STRATMOOR HILLS WATER DISTRICT - CENTRALIZED WATER TREATMENT

SITE DEVELOPMENT PLANS
LOT 2, GLENARM SUBDIVISION FILING NO. 2

PCD Filing No.:
PPR2026

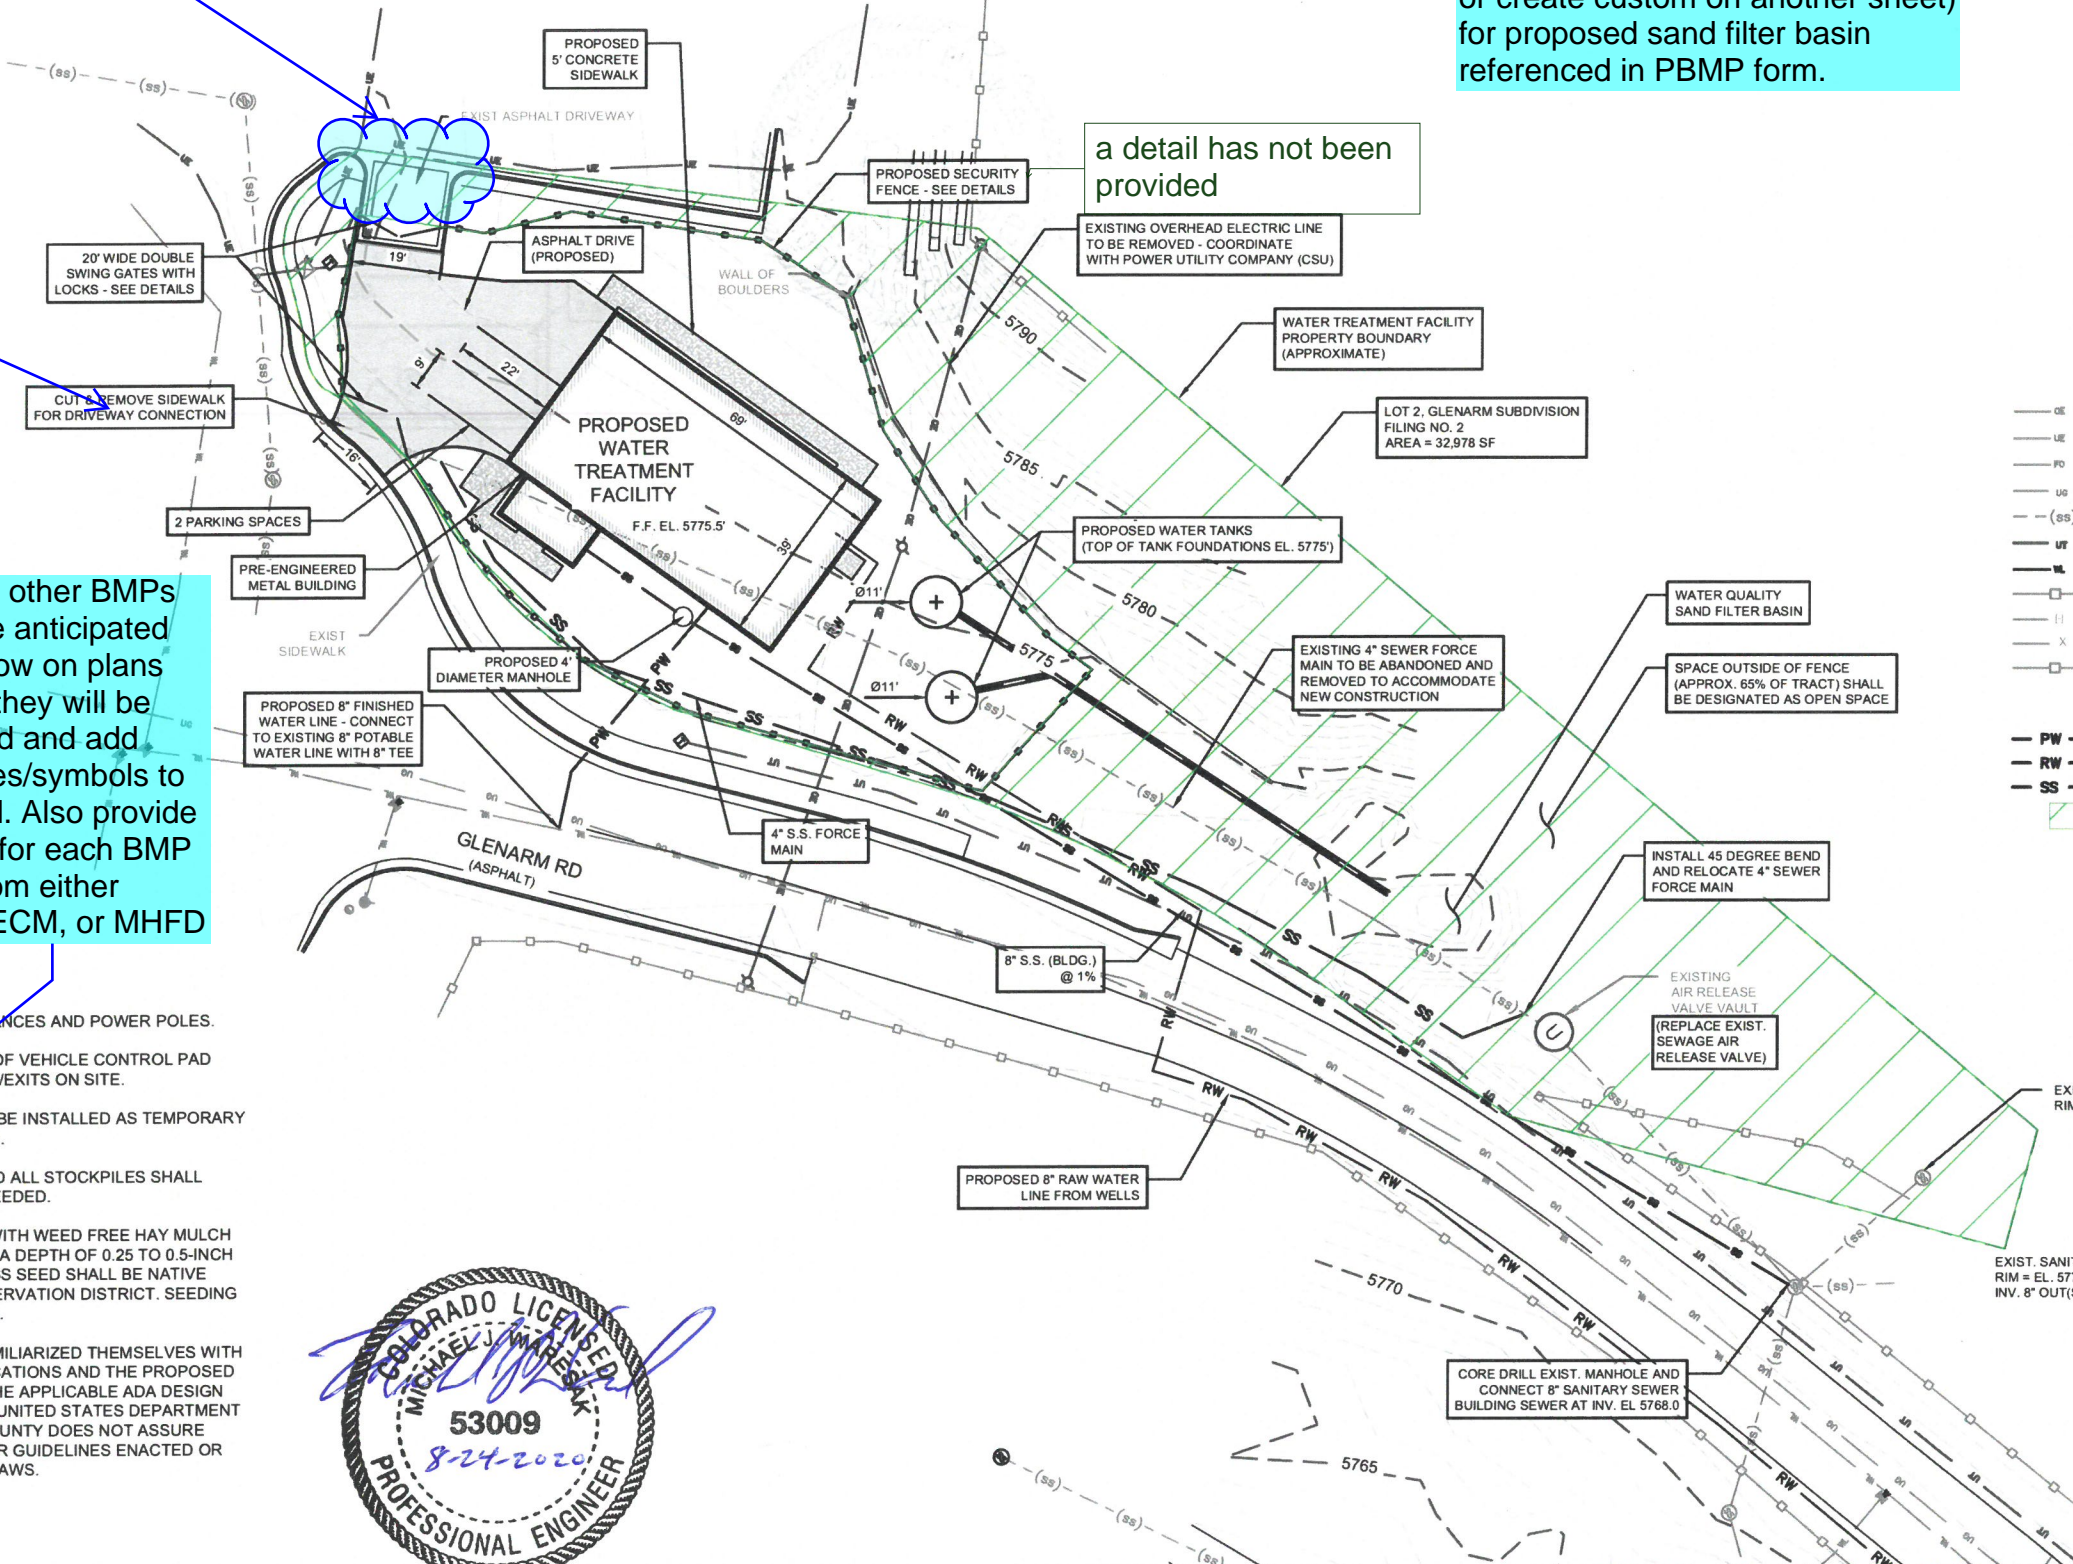
Provide details (either DCM/MHFD or create custom on another sheet) for proposed sand filter basin referenced in PBMP form.

Remove existing driveway and install C&G.

a detail has not been provided

Add: Construct per Standard Detail 2-24

List the other BMPs that are anticipated and show on plans where they will be installed and add linetypes/symbols to Legend. Also provide details for each BMP type from either DCM, ECM, or MHFD

Provide VTC detail (see EPC detail VT-1 and VT-2, or MHFD detail SM-4) and also show locations on plans
